Access Compliance Report

Public Rights-of-Way

Intersection ID: 13535	Main Street: SAM_RYBURN_WALK	Cross Street: CHARLOTTETOWNE_AV	Location: S
ADA ID: 95CCB1B734D1	Ramp Type: PerpDiag	Initial Pass/Fail: Fail	Overall Compliance: No
Codes/Mitigation Info/Possible Solution		Field Measurements/Component Compliance	
Severity Score: 13.75

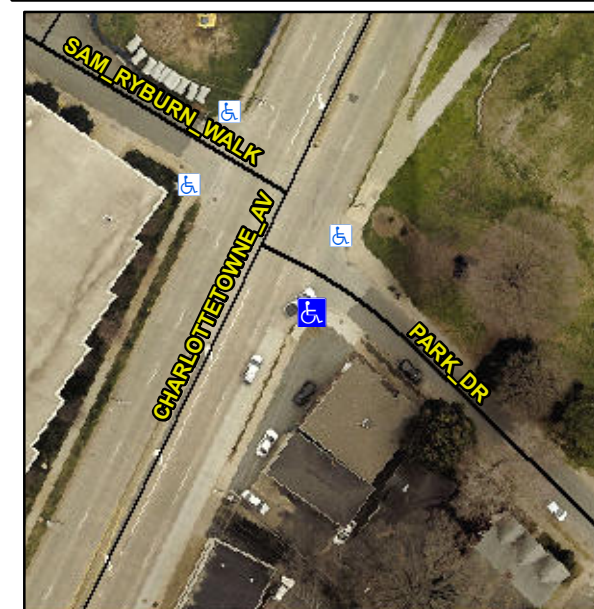
Not Found, R304.2.2, R304.5.3

Compliance	Description	Data	Compliance	Description	Data
N/A	Ramp Length (in)	59.0	No	Ramp Slope (%)	11.4
Yes	Ramp Width (in)	50.0	No	Ramp XSlope (%)	5.0
N/A	Flare Type LT	N/A	N/A	Flare Type RT	N/A
N/A	Flare Slope LT (%)	N/A	N/A	Flare Slope RT (%)	N/A
N/A	Flare Traversable LT?	N/A	N/A	Flare Traversable RT?	N/A
N/A	Landing Length (in)	N/A	N/A	DWS Provided?	N/A
N/A	Landing Width (in)	N/A	N/A	DWS Contrast?	N/A
N/A	Landing Slope (%)	N/A	N/A	DWS Length (in)	N/A
N/A	Landing X Slope (%)	N/A	N/A	DWS Full Width?	N/A
N/A	Landing Curb? (Y/N)	N/A	N/A	DWS Offset (in)	N/A
N/A	Shared Landing?	N/A			
N/A	Gutter Ponding?	N/A	N/A	Gutter Slope (%)	N/A
N/A	Gutter Lip Ht (in)	N/A	N/A	Gutter X Slope (%)	N/A
N/A	Painted X Walk1?	No	N/A	Painted X Walk2?	No
	X Walk 1 Direction	To NE		X Walk 2 Direction	To NW
N/A	X Walk 1 Width (in)	N/A	N/A	X Walk 2 Width (in)	N/A
	X Walk 1 Slope (%)	1.0		X Walk 2 Slope (%)	2.8
	X Walk 1 X Slope (%)	3.6		X Walk 2 X Slope (%)	2.8

Remove & Replace Curb Ramp With Two New Directional Ramps or Equivalent.
